# CITY OF ALBUQUERQUE

RE: **10512 Redbud Residence**  
**10512 Redbud NW**  
**Grading Plan**  
**Engineer's Stamp Date 6/20/17 (File: A12D027)**

Based upon the information provided in your submittal received 6/21/17, the Grading Plan cannot be approved for Building Permit until the following are addressed:

REDBUD RESIDENCE	DRAWN BY WCVJ
	GRADING AND DRAINAGE PLAN	DATE 6-15-17
6/20/17	<p>Rio Grande Engineering 1606 CENTRAL AVENUE SE SUITE 201 ALBUQUERQUE, NM 87106 (505) 872-0999</p>	21752-LAYOUT-6-15-17
DAVID SOULE P.E. #14522		SHEET #
		JOB # 21752

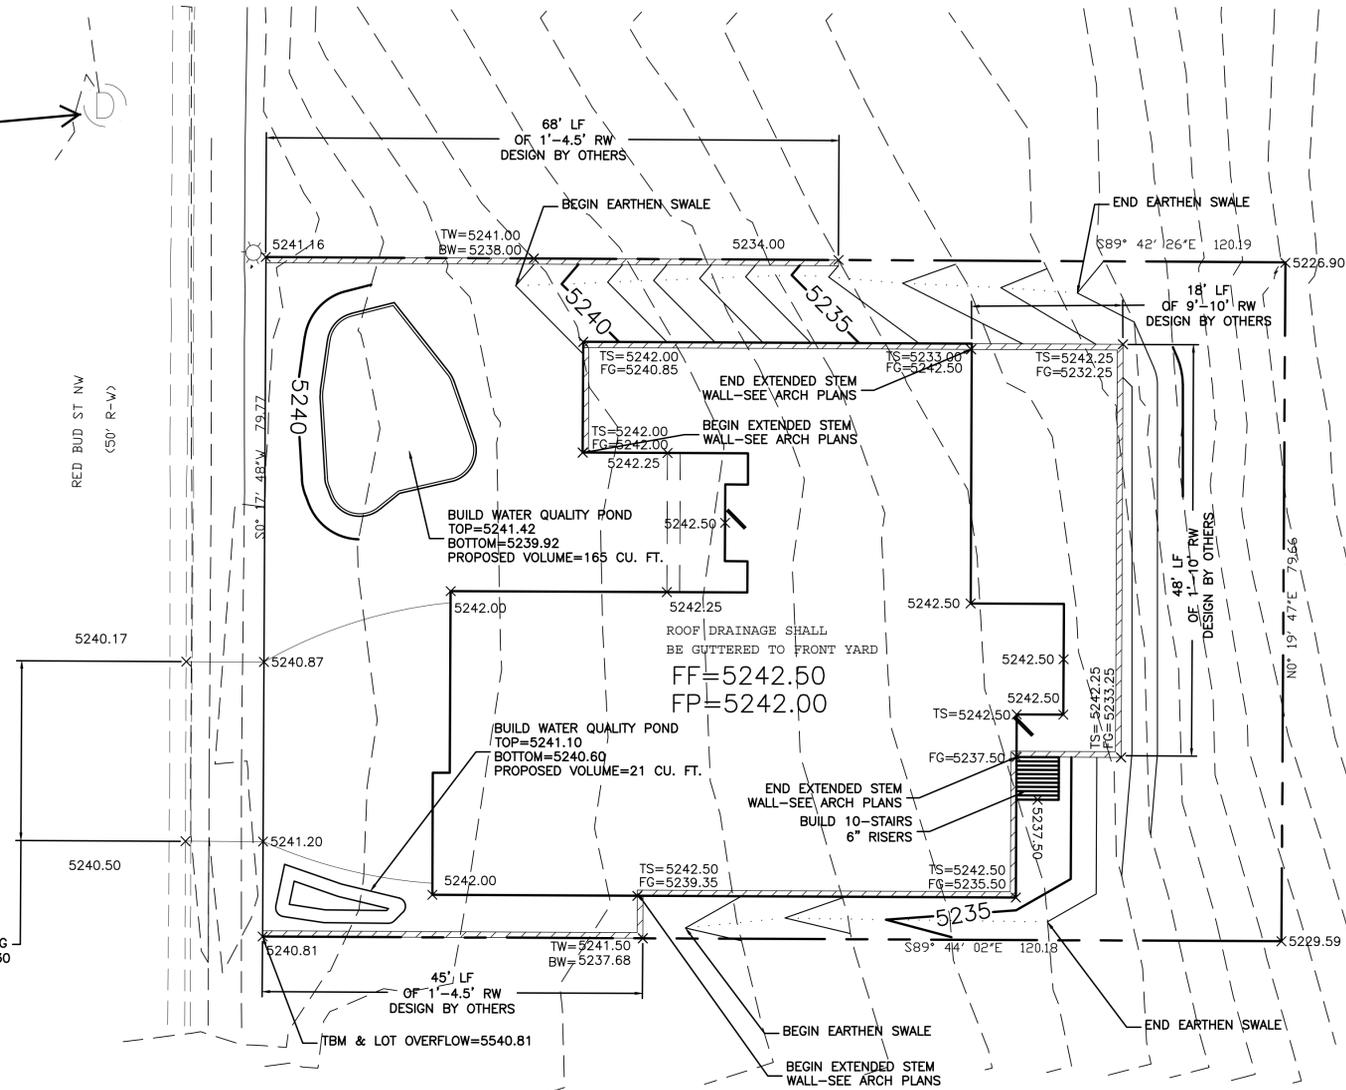
1. Show and calculate the sub-basin divide between the front of lot and back of lot. From the grading plan, it appears about half the site will drain west to the ROW and half to the east to an adjoining lot.
2. For properties that historically drain to an adjoining lot, where the adjoining lot has an outfall, the adjoining lot should not see a change in peak flow. It appears the entire lot historically drained to the adjoining lot, therefore the proposed discharge to the back of this lot cannot exceed 0.38 cfs. This must be demonstrated on the plan.
